HISTORIC PRESERVATION COMMISSION STAFF REPORT

CASE NUMBER: 19/13-7-91A

SITE/DISTRICT NAME: Wallich-Heimer  
House

PROPERTY ADDRESS: Lot 1,  
adjacent to 19120 Mateney Road,  
Germantown

ELEVATIONS

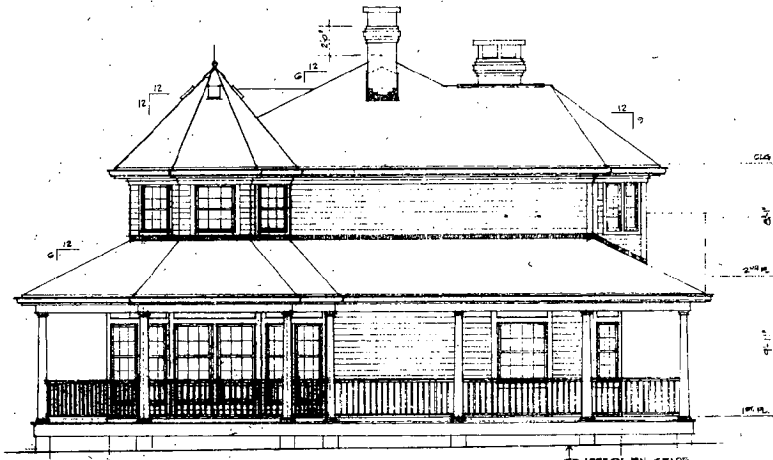
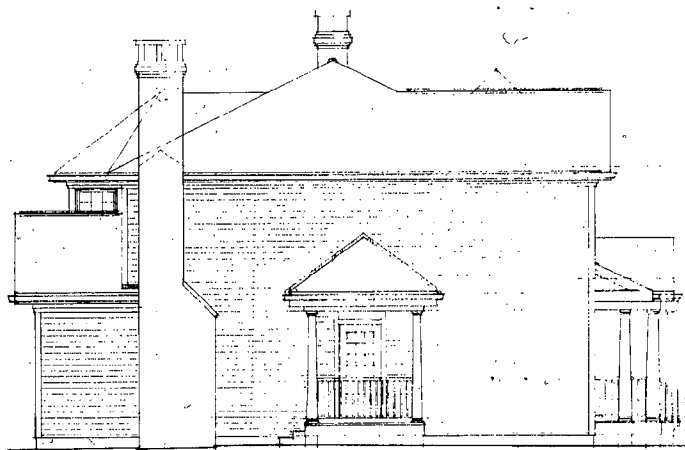
The staff finds that while the proposed house strives to achieve that goal, it still retains the complex massing and articulation that are the hallmarks of the Queen Anne style but that, in fact, were not practiced in this area. The octagonal bay and conical tower on the northeast corner of the proposed house is still a complex element that invites comparison with the simpler tower on the historic house, as suggested by the staff at the October meeting. The size of the new house is still large--1466 square feet, excluding the wrap-around porch and the detached garage--in comparison with the Wallich-Heimer House at under 1000 square feet.

The staff notes, however, that the new house will be built approximately 150 feet from the historic house and that the design has been simplified on all four elevations, particularly where it was most effective to do so: on the southeast corner and south elevation facing the Wallich-Heimer House. The

elimination of the porch and bay and the use of a simple gable with gable returns on the east elevation is to be commended, as is the reduction in massing and use of gable rather than hip roofs on the south and west elevations.

The staff further notes that several elements of the proposed design could be simplified easily and to great effect. 1) The staff recommends that the six-over-six sash be replaced with one-over-one sash, an appropriate configuration for a contemporary house and consistent with historic houses in the area. 2) The staff recommends that double-hung windows with sashes of equal size be used on the first floor of the northeast bay. 3) The staff recommends that plain glazing be used in the front doors and that the octagonal window over the door be replaced with one of a different shape.

The staff recommends approval of the application, provided the applicant address to the Commission's satisfaction the concerns stated in the previous paragraph, based on Historic Preservation Ordinance criterion 24A-8(b)2:
